International Isotopes Inc.

Subject: Response to Request for Additional Information as Discussed during the January 27, 2009 Conference Call in Regards to Revalidation of the Model No. 1860 A Package Revalidate AUS/2007-13/B(U)-96

Subject Answers to Questions arising from the 1860 Teleconference.

Fin Analysis

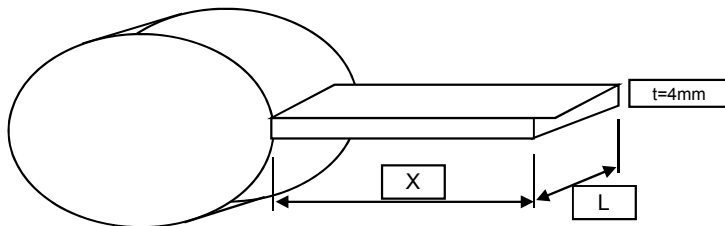
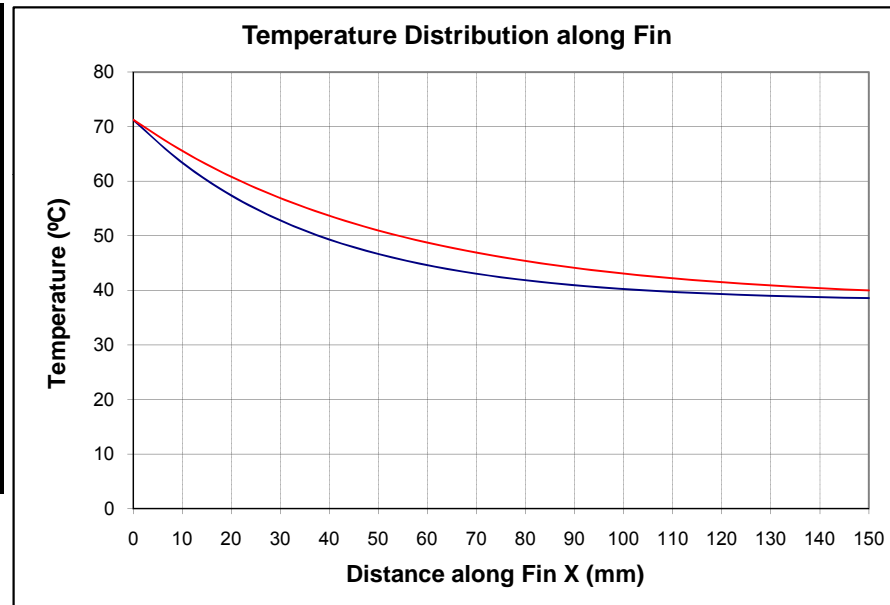
For RAI 2-4, you should consider radiation in your analysis, otherwise there is a potential for your package surface temperature to increase.

Just on a trivial note I've look back over my calculations and found the error/s, i.e. they were just a couple of typos. As you said the net result was a 1°C change in temp at surface of package but still well below limit. I've made corrections (shown in red) in my spreadsheet to show difference, which I've attached for your curiosity. Important thing to note that this is a very conservative result since the heat dissipated through ends of package have not been considered.

Ambient Temperature of air (°C) 38 **311 K**
 Base Temperature of one fin (°C) 71.3 **344 K**
 Convection coefficient air - free convection (W/m²K) **20**
 Convection coefficient assumed to be 20 W/m.K
 Conduction coefficient for Stainless Steel 316 calculated to be: **14 W/m.K**

(initial m value was calculated with P=0.528 when it should have been 0.258)

Distance along Fin X (mm)	Temperature Distribution (°C)	Temp Dist Corrected (°C)
0	71	71
10	63	66
20	57	61
30	53	57
40	49	54
50	47	51
60	45	49
70	43	47
80	42	45
90	41	44
100	40	43
110	40	42
120	39	41
130	39	41
140	39	40
150	39	40

Long Fin assumption verification, i.e. to be valid $m \times L \geq 2.65$
 $m \times L = 4.89$ therefore assumption is valid!
